TO: Design Review Commission
FROM: Jia Liu, Associate Planner
SUBJECT: SC22-0013 – 658 Spargur Drive

Approve design review application SC22-0013 subject to the listed findings

This is a design review application for a new two-story house. The project consists of 2,803.49 square feet at the first story and 1,289.66 square feet at the second story with a 2391.83 square-foot basement. This project is categorically exempt from further environmental review under Section 15303 of the California Environmental Quality Act. The following table summarizes the project's technical details:

**Showing line of basement recommended to be shored****Impacts/Recommendations:**

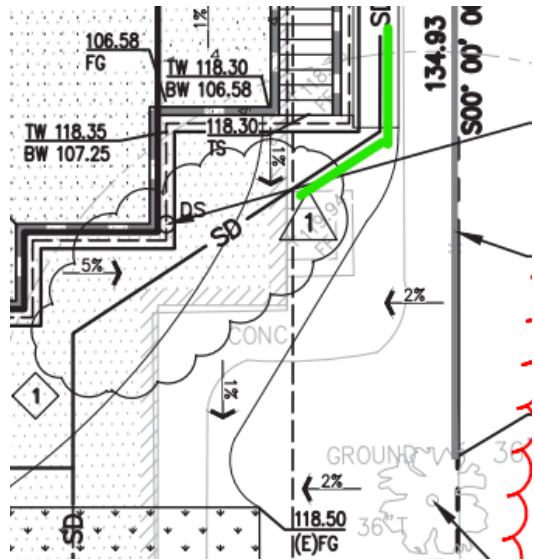
A basement is proposed on site. Most of the proposed basement is within the existing home footprint. The existing home foundation has likely acted as a root barrier for this tree. A portion of the lightwell near Oak tree #3 is outside of the existing home footprint. This section of the light well is located 22' from Oak tree #3. The basement/lightwell on this side of the property is recommended to be shored to reduce the need for a Cal OSHA over cut that would impact more tree roots than necessary. This is likely required as the OSHA cut would be within the neighboring yard. The Project Arborist is recommended to be on site to witness the basement excavation when within 38' from this tree. Any exposed roots during the basement excavation are recommended to be cleanly cut back to the basement wall. Exposed cut root ends are recommended to be covered by layers of wetted down

burlap to help avoid root desiccation. Impacts to the tree are expected to be minor as most of the basement is within the existing building footprint. A soaker hose is recommended to be installed as close to the basement cut as possible and as far from the tree's root crown as possible as a mitigation measure. The hose is recommended to be turned on every 2 weeks for 6 months until the top foot of soil is saturated. After 6 months the soaker hose irrigation shall be permanently suspended. No other impacts are expected.

Green line showing storm drain line area to be hand excavated where outside the existing home footprint and still under dripline

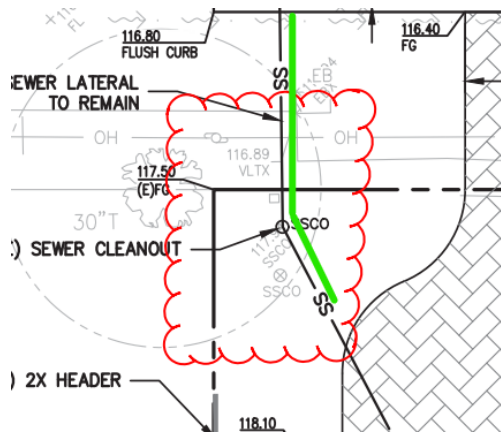
The majority of the storm drain line near Oak tree #3 is underneath the existing building footprint where no roots are expected to be found as foundations tend to act as root barriers. A small portion of the line is within the dripline area outside of the existing home footprint. The storm drain line in this location is recommended to be excavated by hand under the Project Arborist supervision. All encountered roots are recommended to be retained. Encountered roots are recommended to be wrapped in layers of wetted down burlap and kept moist by spraying down the burlap with water multiple times a day. The line shall then be tunneled underneath the exposed roots or besides the exposed roots to reduce trauma to the retained exposed roots. Once the work is done the trench shall be backfilled and irrigated as soon as possible. Impacts are expected to be minor. The Oak tree is recommended to be deep water fertilized in spring of 2023 as a mitigation measure.

Showing recommended tree protection fencing locations for the protected tree surveyed

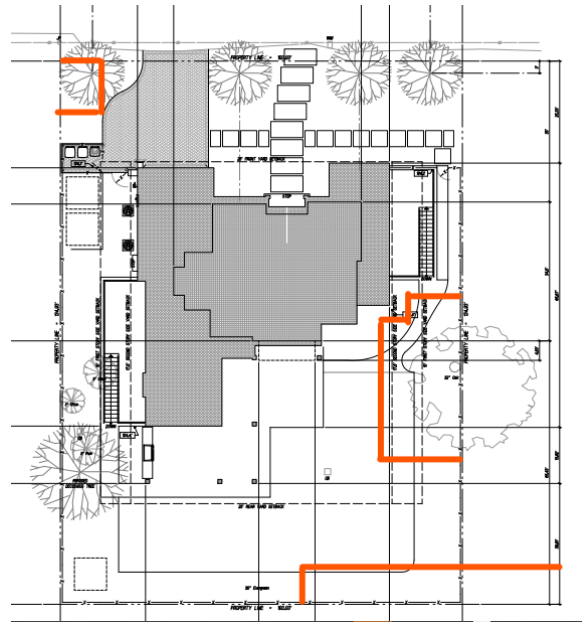
Tree protection zones should be installed and maintained throughout the entire length of the project. Prior to the commencement of any Development Project, a chain link fence shall be installed at the drip line (canopy spread) of any protected tree which will or will not be affected by the construction. Non-protected trees are recommended to also be protected in the same way. The drip line shall not be altered in any way so as to increase the encroachment of the construction. When work is to take place underneath a tree's dripline, fencing must be placed as close as possible to the tree proposed work. If an area of access is needed underneath a tree's canopy, the area shall be protected by a landscape barrier. Fencing for the protection zones should be 6-foot-tall metal chain link type supported by 2 inch metal poles pounded into the ground by no less than 2 feet. The support poles should be spaced no more than 10 feet apart on center. Signs should be placed on fencing signifying "Tree Protection Zone - Keep Out". No materials or equipment should be stored or cleaned inside the tree protection zones. Excavation, grading, soil deposits, drainage and leveling is prohibited within the tree protection zones without the project arborist consent. No wires, signs or ropes shall be attached to the protected trees on site. Utility services and irrigation lines shall all be placed outside of the tree protection zones when possible. When access is needed and tree protection fencing restricts access a landscape barrier shall be installed to protect the non-protected root zone.

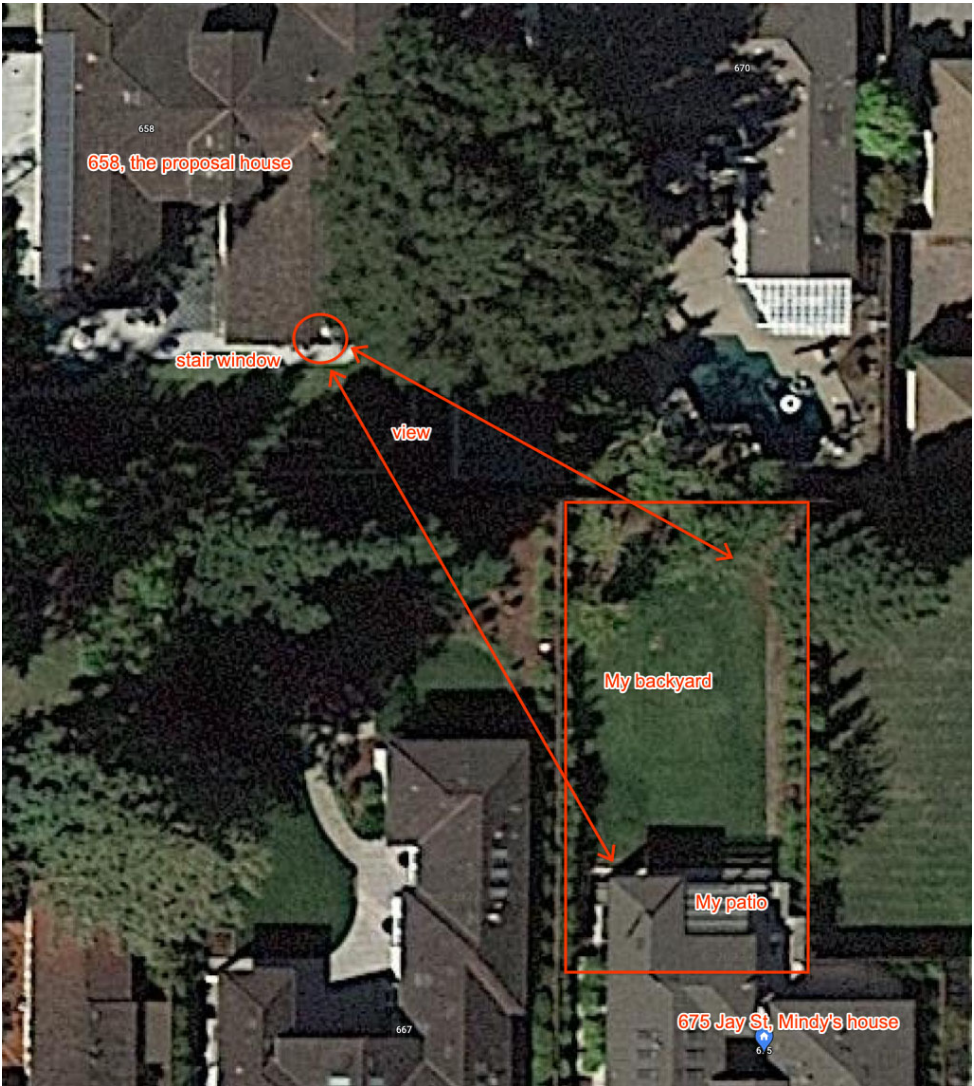
Privacy and security is a huge concern to us with the two-story plan, we would ONLY support it if

- Remove the rear window from the stair landing, add a skylight instead;
- Change all bedroom windows which are in the south and west side to either one:
 1. the transoms window in the height that a normal adult can not reach;
 2. use frosted glass;
 3. no windows, skylights instead;

- We have talked to Pawan before, in the proposed stairs to the second floor, if they stand in the stair, they can clearly see our backyard including our patio, we have 3 kids including a two-year-old daughter, my little one plays in the backyard all the time. We feel very uncomfortable to be peeped intentionally or unintentionally.
- Pawan's modified proposal can not solve our concerns. Just raising the height of the stair window and bedroom 3, and reducing the window size is not good enough. An adult can still peep my backyard by standing in the stair or bedroom 3.
- Adding more trees can not solve our privacy concern, since 1) the privacy concern should be resolved by the design of the house itself; 2) the oak tree in the southeast corner makes it hard to plant other trees around it; 3) even if the trees can be planted, it's hard to guarantee the lives of the trees.

Here I attach the satellite view from Google map to show how much of my private place would be viewed from the second floor of 658 Spargur Dr plan:

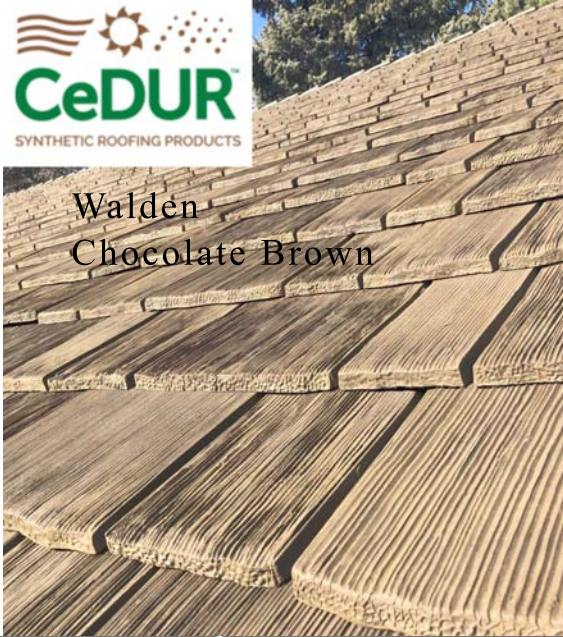
With the windows from The Pawan's newly Proposed plan, their bedrooms on 2nd story will be directly facing our Dining room, Kitchen and Family room area which will be very disturbing to our daily life and privacy

Now , the newly revised plan from the Pawan indicated they will increase the height of the window will to 4'6. Which still not going to solve the privacy issue at all

The Pawan proposed to plant more trees to solve the privacy issue which we do not think it will be helpful. The oak tree and other proposed tree can not fully solve these privacy issue. The trees has their life. Especially it will be very hard for any trees to be grown healthy and last long while they are close to a big oak tree

1. All the bedrooms windows on the 2nd floor that are facing 670 Spargur Dr including the windows in the stairway are using flossy windows

2. All the bedrooms windows on the 2nd floor that are facing 670 Spargur Dr are using transom window
3. All the bedroom windows on the 2nd floor that are facing 670 Spargur Dr , their window sill are over 5feet 2 inch.
